Kingsport Historic Zoning Commission

Project Number: HISTRC25-0306

Property Information			
Address	217 W. Wanola Ave		
Tax Map, Group, Parcel	046I C 004.00		
Civil District	11 th		
Overlay District	Park Hill		
Land Use Plan Designation	Single Family		
Acres	+/- 0.09		
Existing Use	Single Family	Existing Zoning	R-2
Proposed Use	No Change	Proposed Zoning	No change
Owner Information			
Name: B & A Soulitions Address: 217 W. Wanola Ave City: Kingsport State: TN Zip Code: 37660 Phone Number: 423-366-2438 Representative: Brian Fitzgerald		Request: Review and approval for the installation of new doors, replacement of windows, closure of windows on the rear of the residence, removal of front handrails, and exterior painting.	
Points for Consideration			
Request: Review and approval for the installation of new doors, replacement of windows, closure of windows on the rear of the residence, removal of front handrails, and exterior painting.			
When considering this request: Review the following in our Historic Guidelines from Chapter 5 pertaining to the following sections:

Review door, window, and paint for approval. Approve closure of windows on back rooms to ensure proper layout of rooms

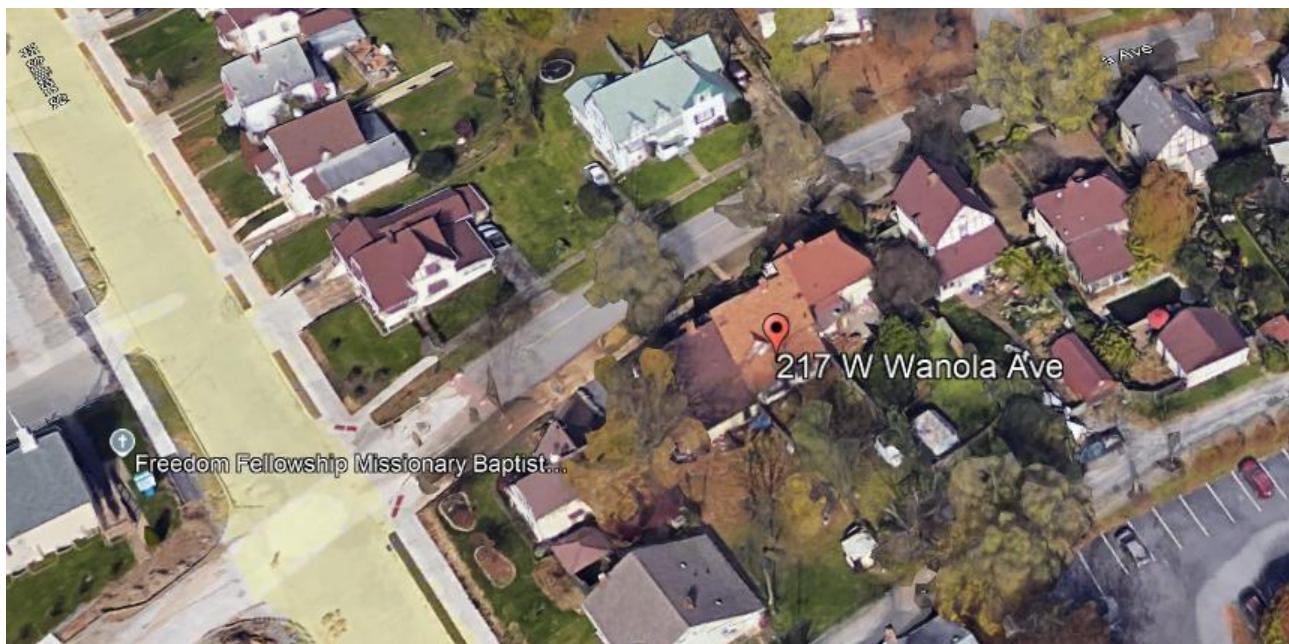
Remove metal storm windows and install new grid windows to allow egress.

Remove storm windows and install new windows.

Fix exterior wood trim and walls and repaint to historic district color scheme.

Remove storm door and paint existing exterior door color matched Glidden "Stewart House Brown" High Gloss

Remove both sides of railing.
